PLANNING & ZONING BOARD - CITY OF WILDWOOD
Special Magistrate – Lindsay C.T. Holt

Agenda
Regular Meeting
March 3, 2026 2:15 PM
City Hall Commission Chamber
100 N Main Street

2. **SP 2410-004 Exalt Health Rehab Hospital Offsite Force Main Extension**

3. **25-2593 - SP - Hampton Substation (SECO)**

SHT. 04.06

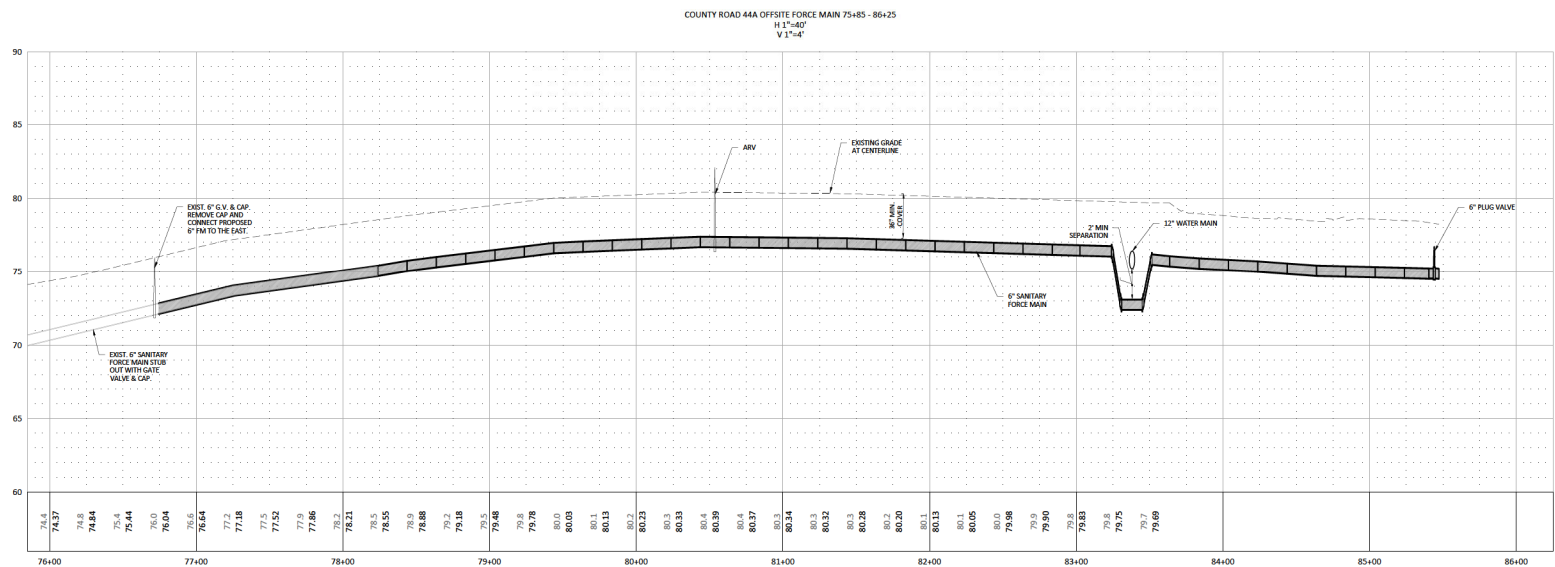
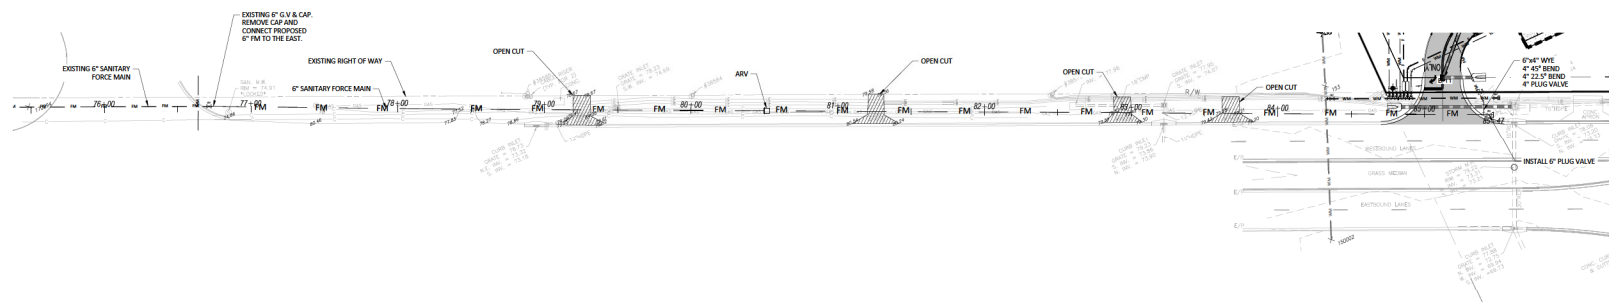
- I. Response Acknowledged; Standing comment.**
2. Sheet 04.06 – No right of way or easements shown for portion of the proposed line. Please mark any easements that may apply. Further discussion may be necessary.

- A. Response: That area is within the RxR R/W and will be handled with the RxR permitting.
 - I. There remain areas that are outside the railroad right of way that are not shown to have right of way. Sheet 4.07, not sheet 4.06 shows the railroad line. There is no “existing right of way” shown for the majority of Fifth Avenue on that sheet. Additionally, there may be other areas without shown right of way. The City cannot clear the installation of lines without appropriate right of way and/or easements. Accordingly, please review comments nos. 6, 9, and 10 again.

- a. Response: Please see the revised plans.
 - i. Not Satisfied.
 - a) Response: The R/W for CR 44A and the RxR has been shown and labeled. Most of Fifth Avenue on Sheet 04.06 is in the RxR R/W. There is not a separate road R/W within the RxR R/W. The plan shows where the Fifth Avenue R/W to the south connects to the RXR R/W. There is an utility easement shown on sheet 4.07 along the southern portion of the school board property.**

- i) Satisfied.**
3. City Attorney reserves the right to make further comments upon resubmittal.
 - A. Response: Acknowledged.
 - I. Standing comment.**
4. LDR 4.4(D)(6) – Please provide copies of all proposed or executed easements, for cross-access, water and wastewater utilities or other required easements if applicable.
